### Proposal for Amendment 1 to global technical regulation (UN GTR) No. 16 (Tyres)

#### Submitted by the Working Party on Brakes and Running Gear\*

The text reproduced below was adopted by the Working Party on Brakes and Running Gear (GRRF) at its eighty-first session (ECE/TRANS/WP.29/GRRF/81, para. 30). It is based on ECE/TRANS/WP.29/GRRF/2016/2. It is submitted to the World Forum for Harmonization of Vehicle Regulations (WP.29) and to the Executive Committee (AC.3) of the 1998 Agreement for consideration.

## Global technical regulation on tyres\*

Figure 1

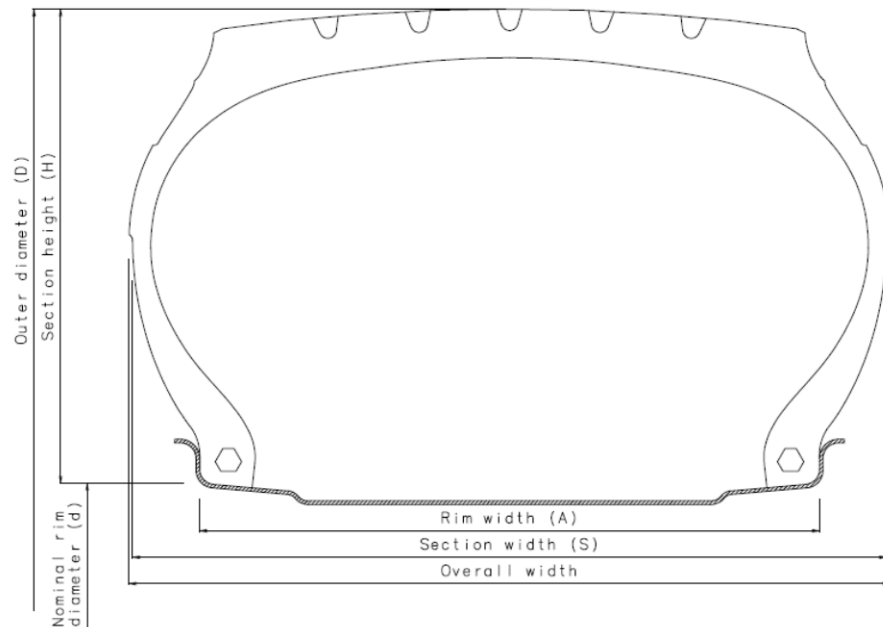
**Comment [5847]: Proposal for amendments to Regulation No. 30 (Uniform provisions concerning the approval of pneumatic tyres for motor vehicles and their trailers)**  
ECE/TRANS/WP.29/2016/51
